EXTRACT FROM COUNCIL MEETING MINUTES OF OCTOBER 2, 2019

1. BLOCK 18 PROPERTIES INC. DRAFT PLAN OF SUBDIVISION FILE 19T-19V003 VICINITY OF GRAND TRUNK AVENUE AND MURET CRESCENT

TITLE: BLOCK 18 PROPERTIES INC.

DRAFT PLAN OF SUBDIVISION FILE 19T-19V003

Draft Plan of Subdivision File 19T-19V003

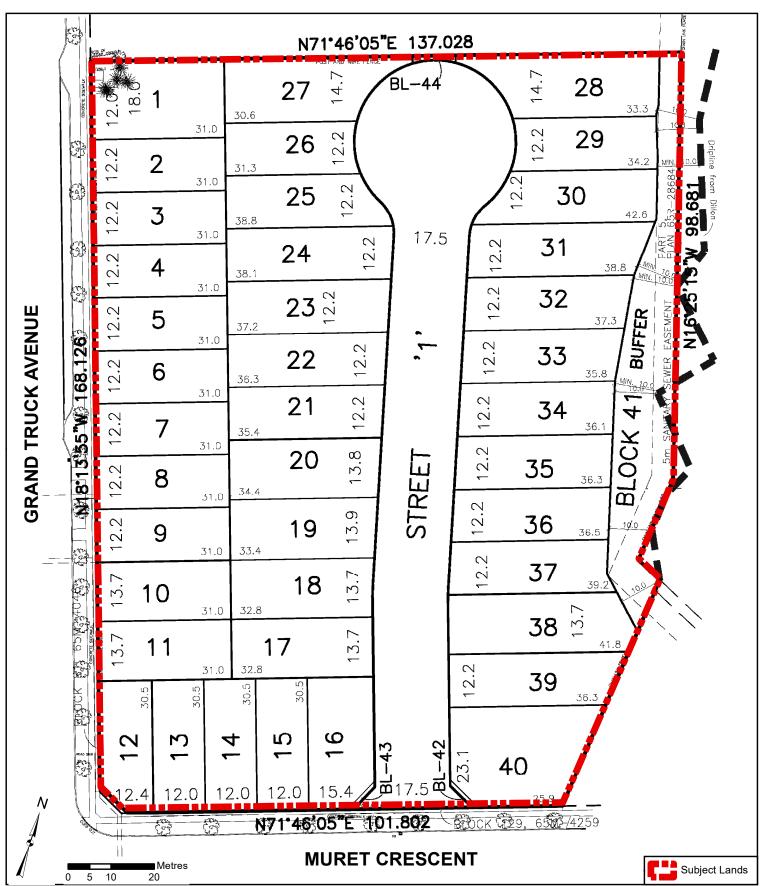
h.	Parks Development Department	 The Owner will be required to submit a revised grading plan and a walkway scoped report for the walkway proposed from the Subject Lands into the adjacent neighbourhood park (Attachment 2). Appropriate mitigation measures such as increased setbacks and/or fencing will be required to address noise and safety concerns

- 1. Has a traffic study been conducted to look at the feasibility of a cul-de-sac being attached to Muret Cres. mid block?
 - a. This design is inconsistent with the rest of Block 18 why would the access to this new development not enter off of Grand Trunk which is a main feeder street.

- b. Does this plan include any additional consideration for the width of Muret Cres?
- 2. Has an Environmental assessment been conducted? Lots 28-37 are adjacent to the existing wooded lot is the set back for the house sufficient given the slope of the land?

- 4. While I understand that this lot was originally planned for a school and so the underlying zoning was RD4 the proposed development is very dense and inconsistent with the surrounding houses.

Overall my request is for the planning department and for the City Council to consider a development plan that is more considerate of the neighbourhood. I would like to see the development be connected to the main feeder road (Grand Trunk) and I would like larger lot frontages.
